APEX MAIN EMS STATION

6950 APEX BARBECUE ROAD, APEX, NORTH CAROLINA 27502 | WAKE COUNTY REQUEST FOR BIDS NUMBER: RFB-23-080

ADDENDUM NO. 1

DATE: OCTOBER 17, 2023

MSA PROJECT NUMBER:
600-19-01

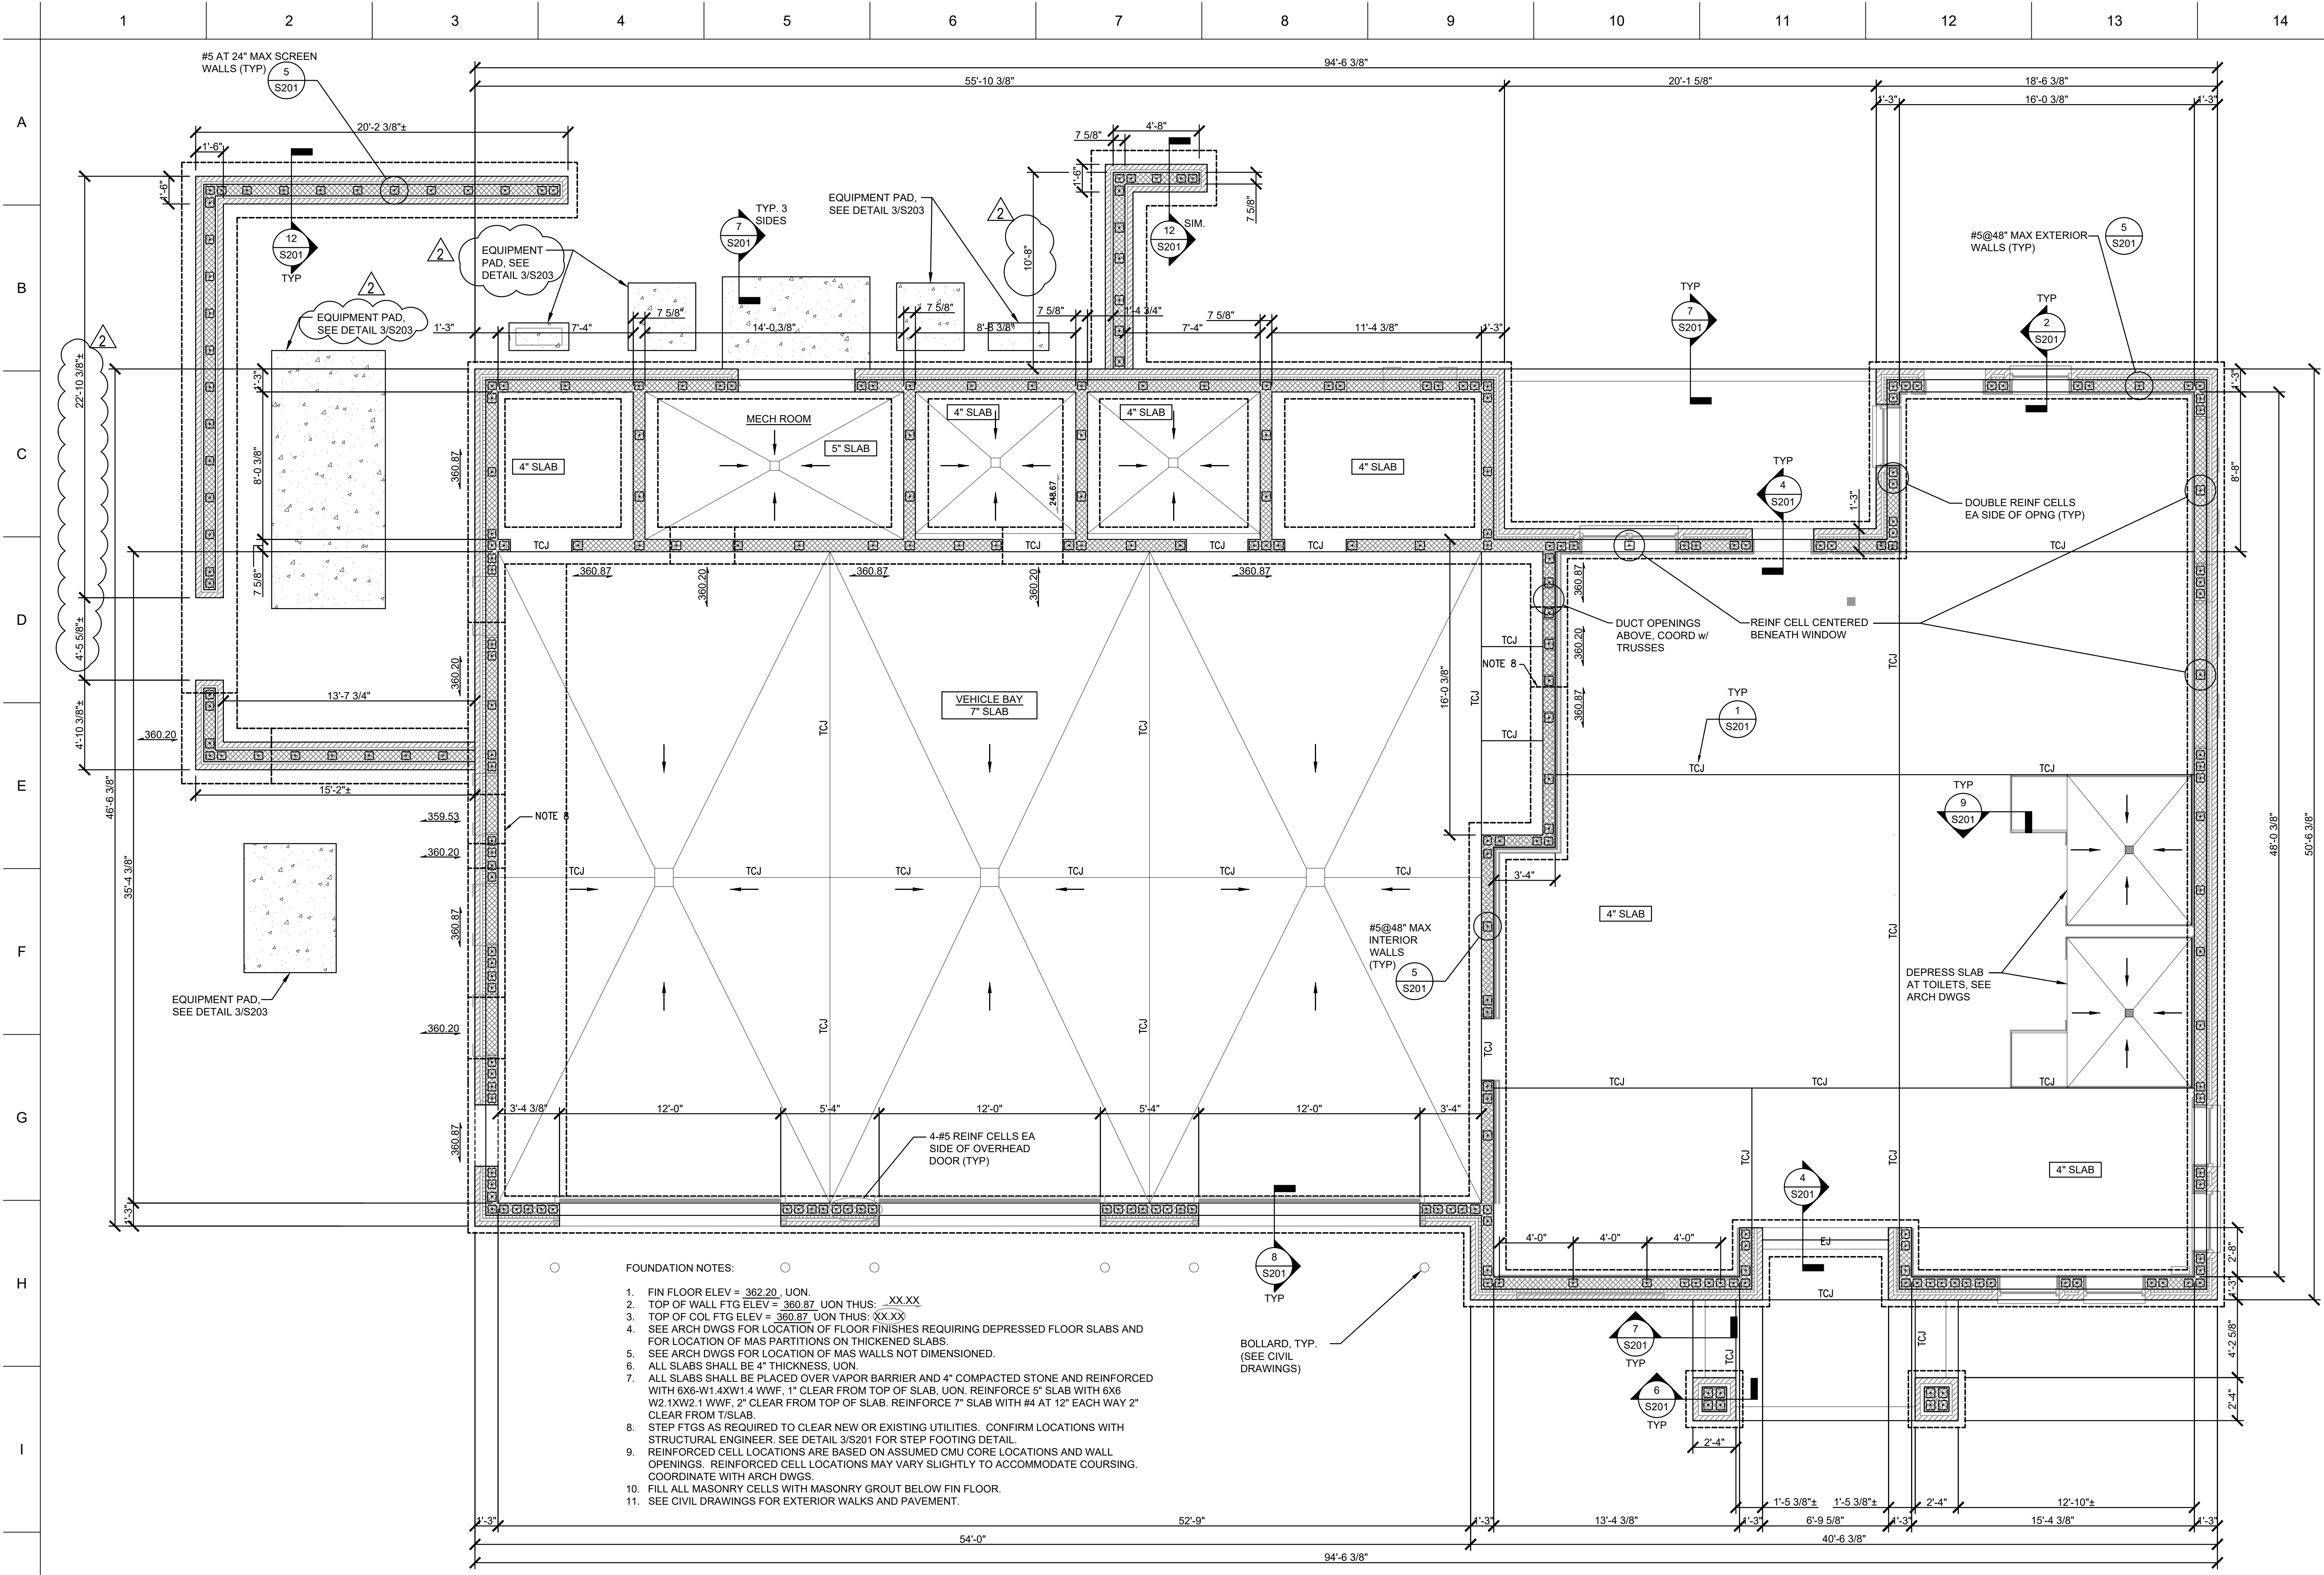
1. **REPLACE** Sheet G103 – Code Summary with the attached, updated G103 – Code Summary (Revision 2, Dated 10/11/23). Detail A9/G103 – Life Safety Plan | Egress and Detail F9/G103 – Life Safety Plan | Rated Walls base plans updated.
